Executive Director's Recommendation

Commission Meeting: July 9, 2015

PROJECT Vietnam Veterans Memorial Visitor Center Lincoln Memorial Washington, DC	NCPC FILE NUMBER 6597
	NCPC MAP FILE NUMBER 1.43(38.00)44167
SUBMITTED BY United States Department of the Interior National Park Service	APPLICANT'S REQUEST Final approval of site and building plans
REVIEW AUTHORITY Approval per 40 U.S.C. 8903, 40 U.S.C. § 8905, and 40 U.S.C. 8722(b)(1) and (d)	PROPOSED ACTION Approve as requested
	ACTION ITEM TYPE Staff Presentation

The National Park Service, on behalf of the Vietnam Veterans Memorial Fund, has submitted final site and building plans for the Vietnam Veterans Memorial Visitor Center (Visitor Center). Public Law 108-126 (2003) authorizes the Vietnam Veterans Memorial Fund to construct the Visitor Center at or near the Vietnam Veterans Memorial on Federal land "in order to better inform and educate the public about the Vietnam Veterans Memorial and the Vietnam War." It also required that the Visitor Center be located underground. In August 2006, the Commission approved a site for the Visitor Center on the northern grounds of the Lincoln Memorial. The site is located west of the Vietn

Figure 3: Final site plan for the Visitor Center

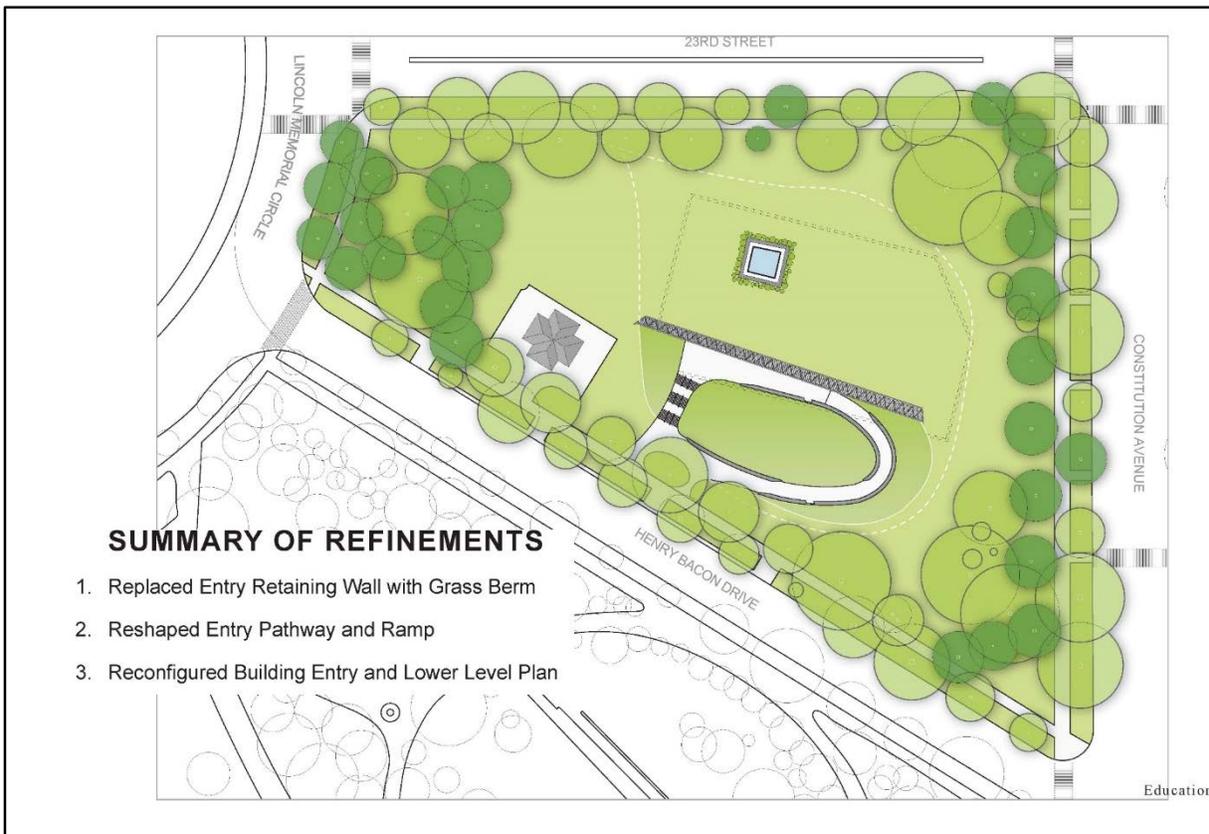
Modifications to the Visitor Center since the Commission's preliminary approval are in response to comments, concerns, and suggestions from the Commission as well as the U.S. Commission of Fine Arts (CFA) and other interested stakeholders. To satisfy life safety and egress concerns of NPS code officials, a second means of egress was added to the entry path. The final site plan incorporates two means of entry and exit from the Henry Bacon Drive sidewalk.

Comments concerning the similarity of the form of the Visitor Center (two perpendicular walls) to the Vietnam Veterans Memorial, necessitated other changes to the design. The retaining wall adjacent to the entry stair has been removed, and a gradual grass berm at a 3:1 slope has been incorporated into the landscaping. In order to realize the minimum slope of the lawn down to the lower plaza and have room to enter the building, the building shifted 22 feet to the north. The exterior stair remained in the same position. In order to protect the sloped lawn, the horizontal rail increased in size by approximately 22 feet to the north and 23 feet to the south and its total length is now 248 feet. The entry doors to the building were also relocated so that the doors are on axis with the entry stair. In the preliminary plans approved by the Commission, the entry doors were not on axis with the stair, but were adjacent in a covered "forecourt". Due to removal of the retaining wall and the changes to the entry, there were also modifications to the entry and lower level floor plans. However, the overall size of the building remains the same at 37,000 square feet.

In response to comments from the CFA in 2014, the grass berm defined by the surrounding entry ramp has been reshaped. In the final plans, this berm takes on an organic shape rather than an ellipse. CFA's comments indicated that the form of an ellipse was inwardly focused and did not respond to the open curves of other areas along the National Mall such as Constitution Gardens and the linear geometry of the Lincoln Memorial.

Figure 8: View of the Visitor Center from the Lincoln Memorial

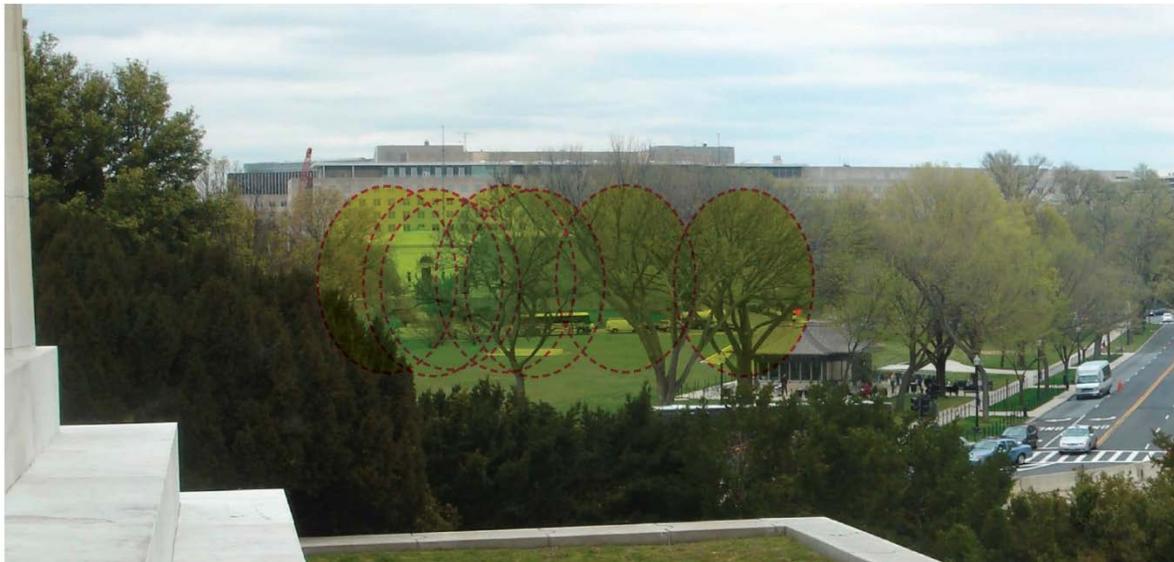
The Visitor Center has been designed as an underground facility. Portions of the courtyard and horizontal rail are visible from the Lincoln Memorial steps and podium. Though these elements will be visible, trees to be planted as part of the landscape plan for the project will help mitigate the impact on the view. By incorporating a curved entry ramp that surrounds a green berm, the visibility of the sunken entrance from the surrounding streets has been minimized and reduced the impact that the Visitor Center will have on the landscape. In addition, by raising the grade of the site and with the design of a green roof to cover a portion of the courtyard, the Visitor Center will be minimally visible from the intersection of Constitution Avenue and 23rd Street. While a portion of the Visitor Center (horizontal rail) will be visible from Henry Bacon Drive, the building does not dominate the view shed.

Figure 11: Proposed grade change

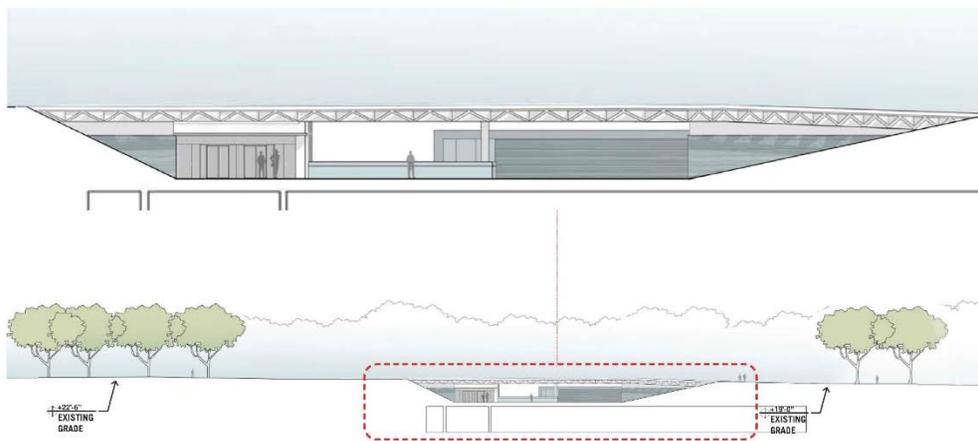
As was proposed in the preliminary plans, the design of the Visitor Center will raise the grade of the site by 3'6" in order to accommodate the curved entry ramp. The entryway to the Visitor Center will be at an elevation of 7' and the slope of the curved ramp is gradual in order to descend from the top of the ramp at an elevation of 20' AMSL. While the grade is proposed to be raised, it is to allow an accessible entry ramp and the character of the landscape will be maintained.

Figure 14: Detail of ha-ha condition at courtyard opening

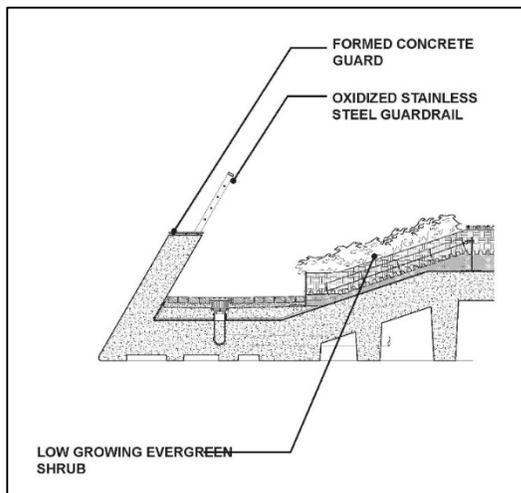
The design of the Visitor Center incorporates a horizontal rail along the edge of the green roof to protect against potential falls. The horizontal rail eliminates the need for vertical guardrails. The ha-ha condition around the courtyard opening features a concrete guard wall capped with an oxidized stainless steel guardrail. These elements were both included in the preliminary plans, and though they will be visible, the number of vertical elements has been kept to a minimum.

Figure 16: Detail of horizontal rail

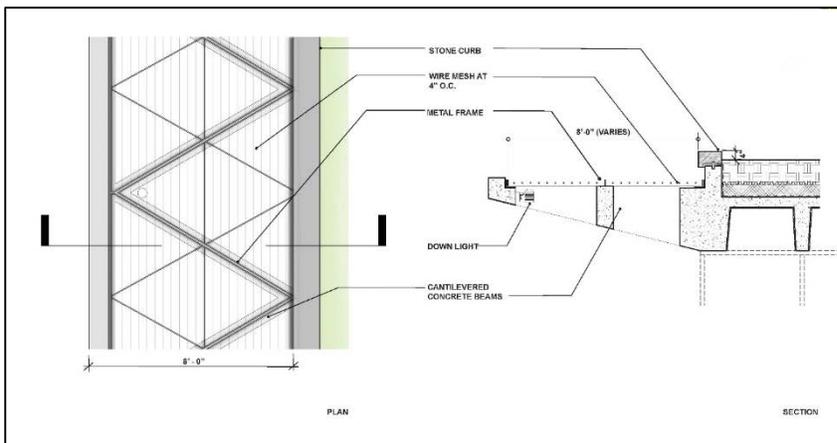
The horizontal rail has increased in size by approximately 45 feet since the Commission approved the preliminary plans and will be approximately 248 feet in length. The increase in length is needed to protect the 3:1 slope that has replaced the retaining wall adjacent to the entry stairs (on the south). The horizontal rail increased by 23 feet to the south and approximately 22 feet to the north to protect the slope. In exchange for a larger horizontal rail, the Visitor Center has only one façade and its form is distinct from the Vietnam Veterans Memorial. This modification was specifically made in response to CFA comments concerning the similarity of the Visitor Center (preliminary

Staff notes that the color and finish of the horizontal rail is critical to minimizing its visibility particularly given its increase in size. Staff has requested that the National Park Service continue to work with the design team and appropriate review agencies regarding the finish and color of this element. The National Park Service has agreed to consult further on the final finish and color of the horizontal rail and staff is recommending that the Commission **notes the National Park Service will review the final finishes and color selection of the horizontal rail in consultation with review agency staff, as appropriate, to ensure compatibility with the surrounding context and minimize its appearance.**

Notes the National Park Service will review the final finishes and color selection of the horizontal rail in consultation with review agency staff, as appropriate, to ensure compatibility with the surrounding context and minimize its appearance.
